intel® Technical Advisory

TA-751-1

Installation of 4-Pin Processor Fan Heatsink Connector on Intel® Server Boards SE7520BD2 with 3-Pin Fan Headers

Figure 1: 3-pin and 4-pin heatsink fan connector

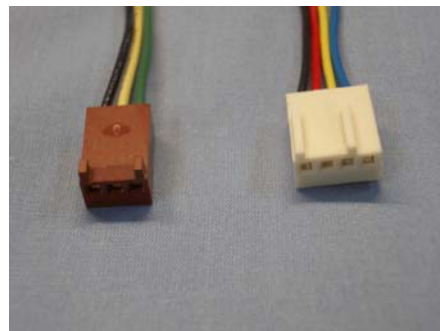
The 64-bit Intel® Xeon™ processor with 800MHz system bus and 2MB of L2 cache is shipping with a new heatsink fan which has a 4-pin connector (refer to figure 1 below). Processor heatsink fans are included only on the active boxed processor SKUs, passive boxed processor SKUs will continue to ship a heatsink with no fan. When integrating the Intel® Server™ Board SE7520BD2 into the Intel® Server Chassis SC5300, the passive version (no fan) of the Intel® Xeon™ processor must be used. For integration into the Intel® Server Chassis SC5275-E or in instances where the server board is integrated into a third party chassis the active heatsink solution may be required to meet the processor cooling requirements.
